Re: Improving the Safety, Comfort, and Character of I-35 Frontage Roads

Our request is straightforward: build a frontage network that is safe, shaded, and multimodal on Day 1, and formalize the collaboration to achieve it. Specifically, AIA Austin asks TxDOT to:

I-35 CapEx Central Project

Cross-Section through Median at Frontage Road, Looking North

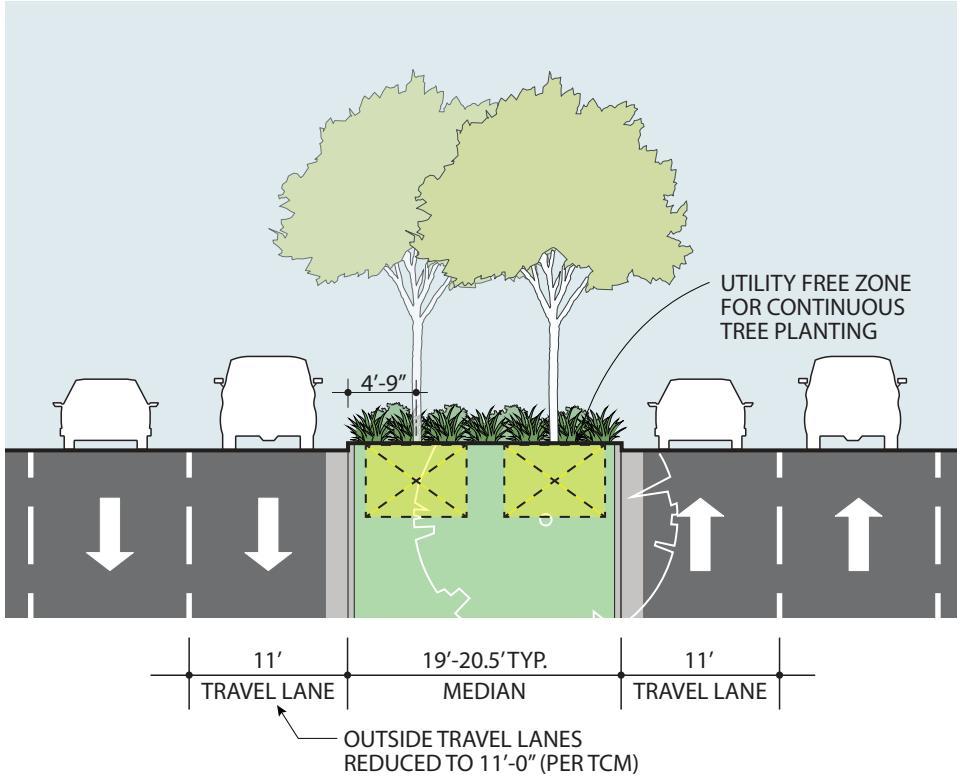
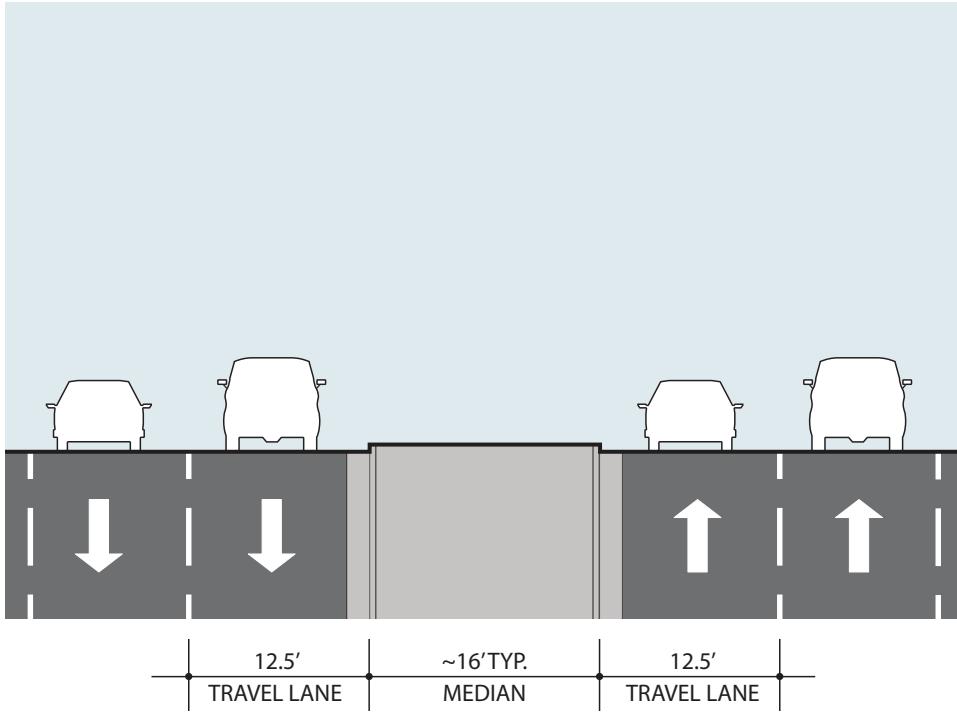
- The TxDOT Design is a cross-sectional depiction of the plan view roll-plots of the 8.5.2025 Design, as posted on the txdot.gov/mymobility35/projects/capex-central.html website. As no cross-sections or elevational information were provided, this cross-section is conceptual only.
- A minimum Utility Free Zone of 7' wide X 5' deep is required to allow for shade trees to be planted in a continuous trench, per the Concept Tree Planting Detail found at the end of this package. It is critical to ensure that no underground utilities are located within this zone.
- Trees planted in a continuous trench each require a minimum soil volume of 750 cu ft. Individually-planted trees require a min. soil volume of 1,000 cu ft.
